181202 TAAB

**LORETO NORMANHURST**  
**P3 Osborn Road Driveway Review**

**Re: Loreto Normanhurst – Early Learning Centre (ELC)  
Response to Deferral Decision; Traffic and Transport**

**Figure 1: ELC Original Parking Strategy**

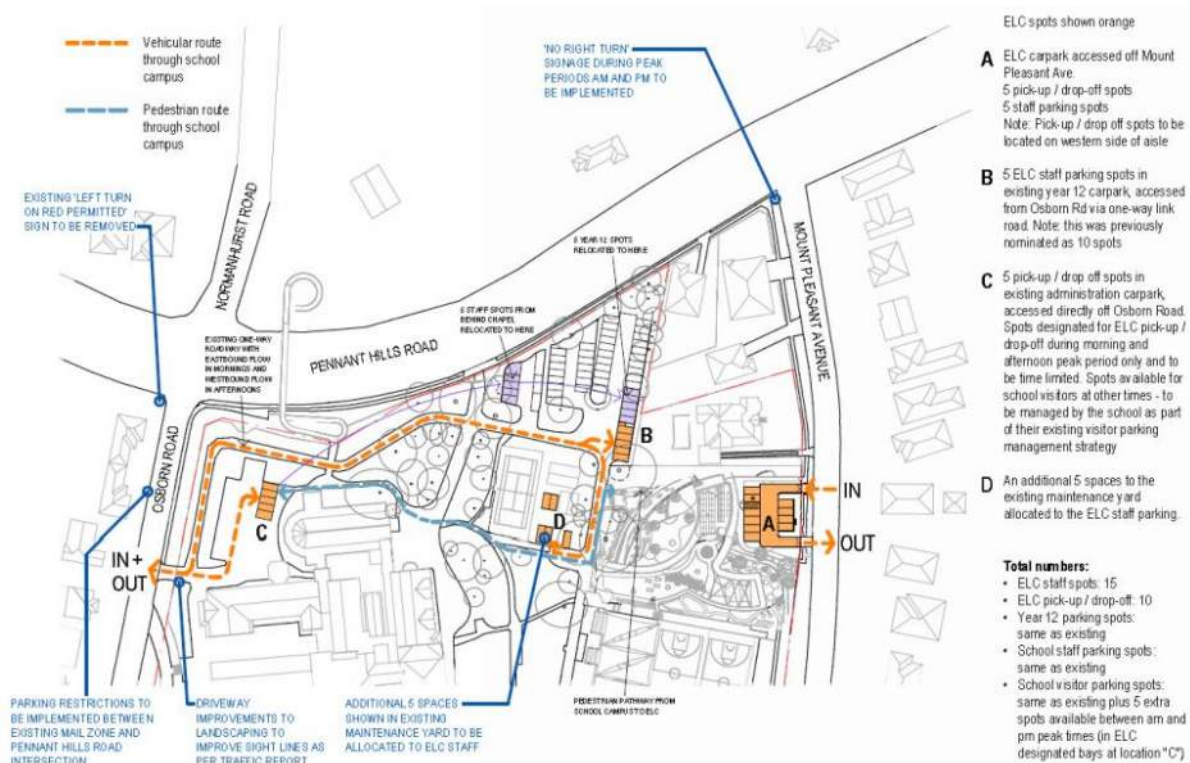
- *The location of the 15 car parking spaces to be dedicated for Early Learning Centre use*
- *The purpose of the layover area outside the front entrance (P4 Primary car park) of the Boarding Accommodation building*
- *How the above space will be managed to prevent casual parking / general student pick up/drop off*
- *Whether bicycle parking and end of trip facilities will be provided in accordance with the Hornsby DCP.*

The 15 spaces required for the Early Learning Centre development application will be located within the spaces shown in Figure 1, once the P1A carpark and through site link is constructed, the parking spaces that will be impacted by the works (at location 'B' and 'D' in the figure) will be located within the P1A car park. These spaces will be clearly line marked as well as indicated to staff as part of the staff allocation discussed in Section 6.2.1 of the Operational Traffic Management Plan.

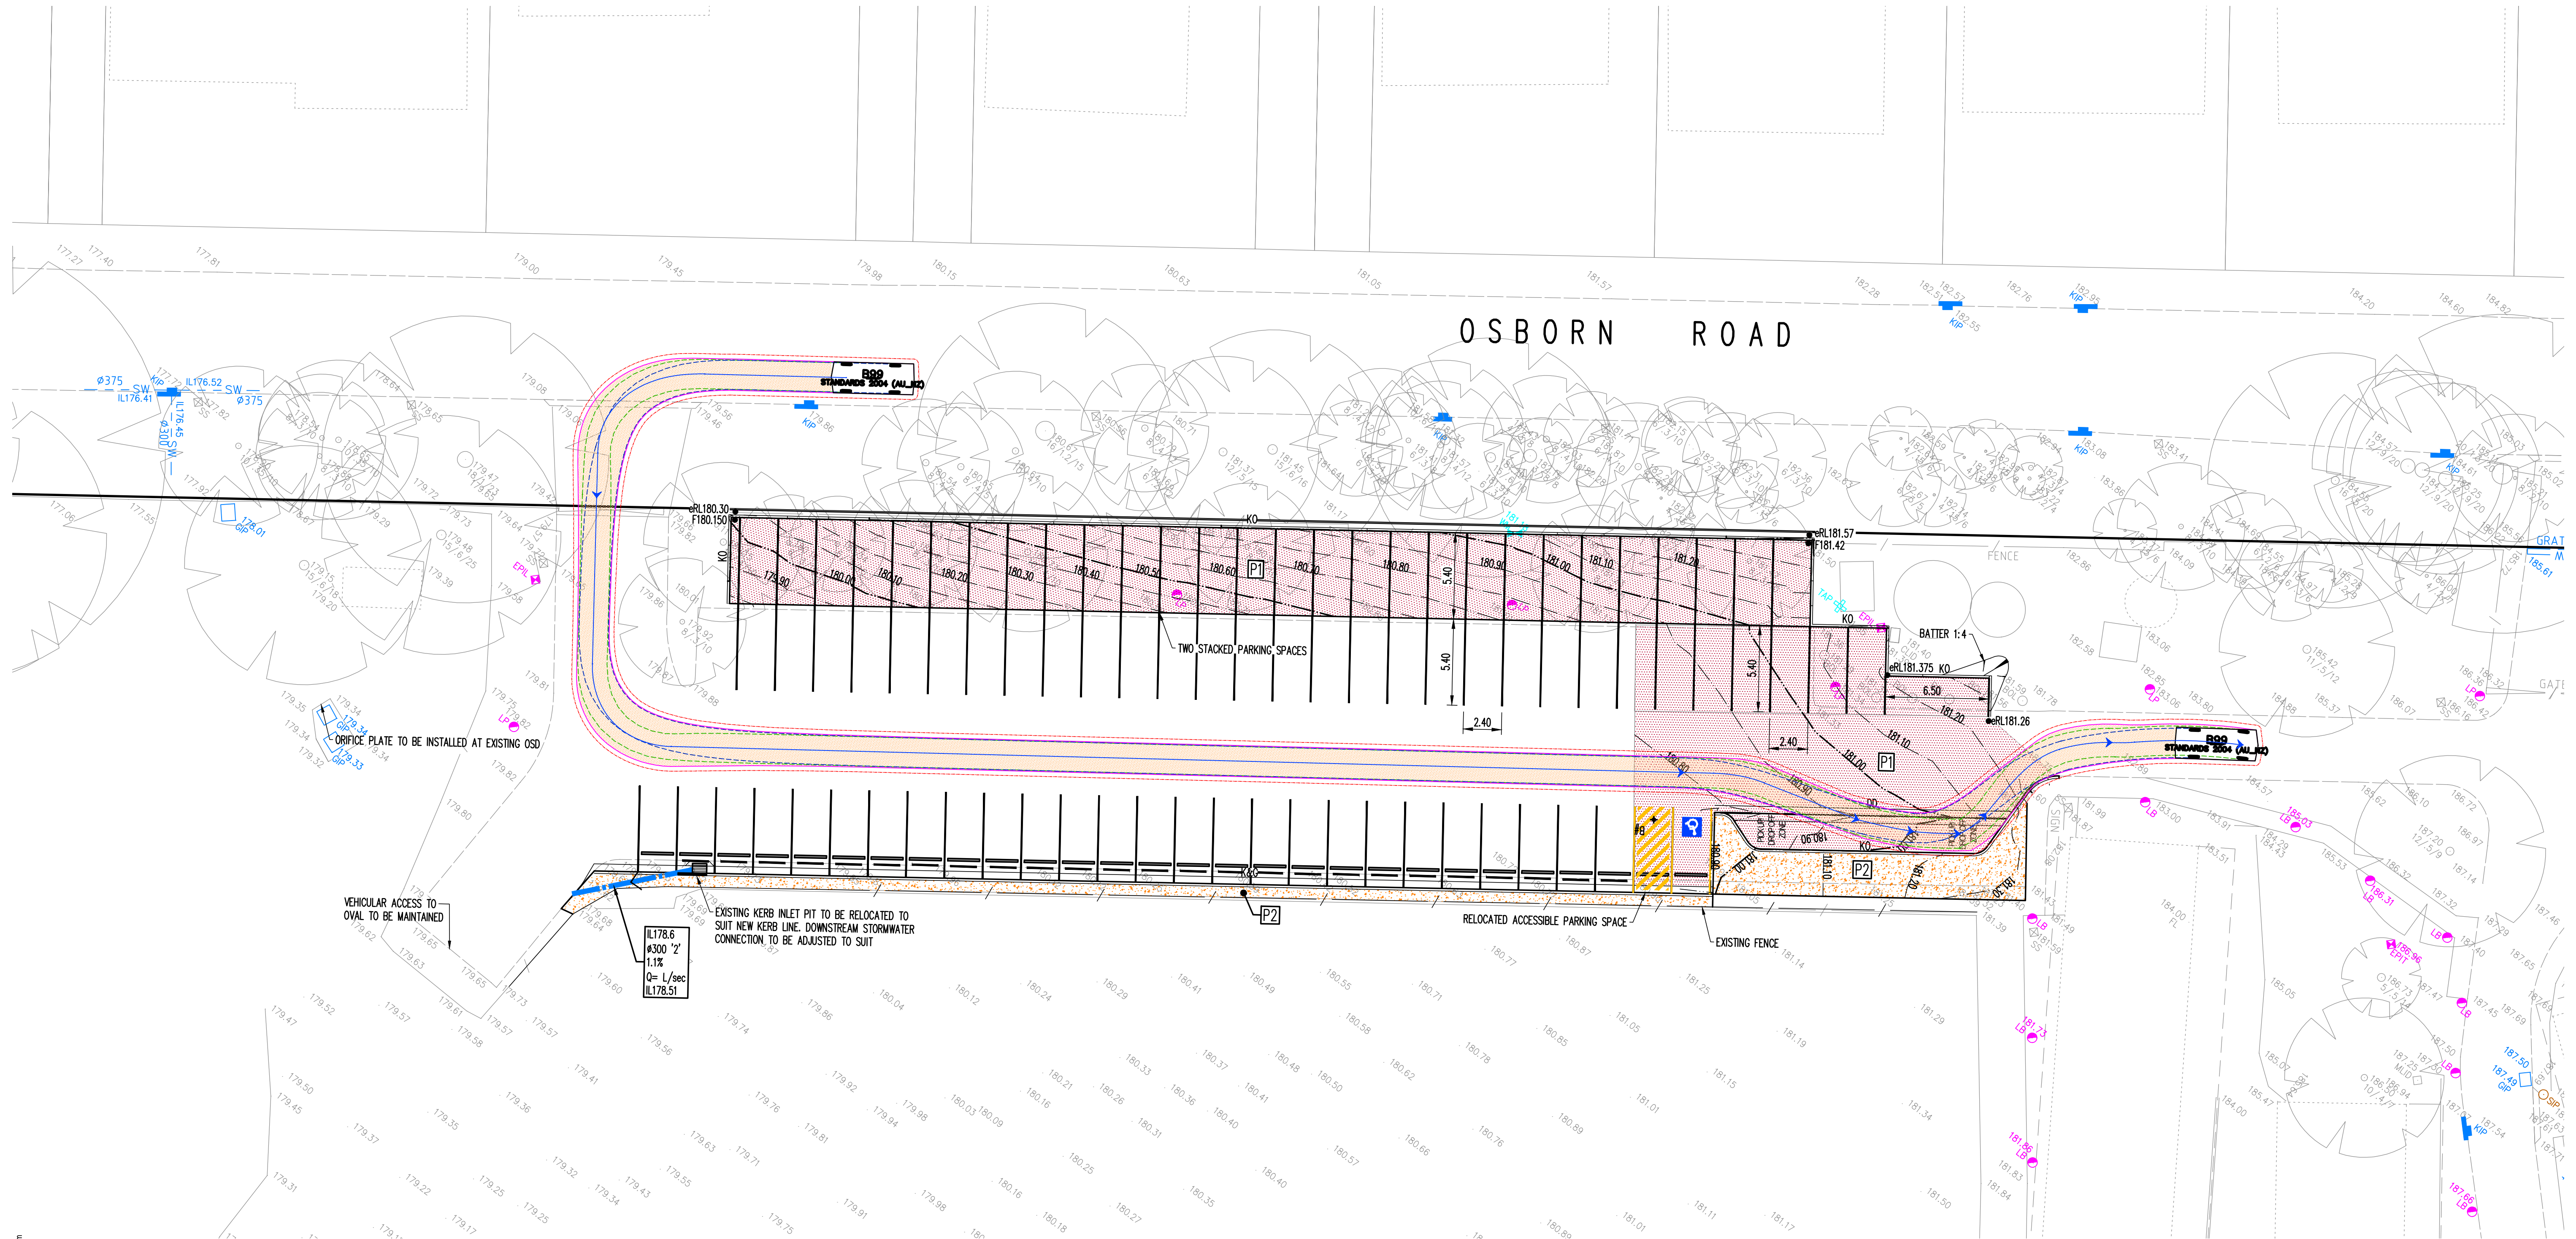
*Please provide swept path diagram(s) for the P3A Osborn Road car park pick-up/drop-off area to demonstrate that vehicles have sufficient space to turn around when leaving.*

Refer to Appendix A attached for a swept path diagram of the P3A Osborn Road car park.
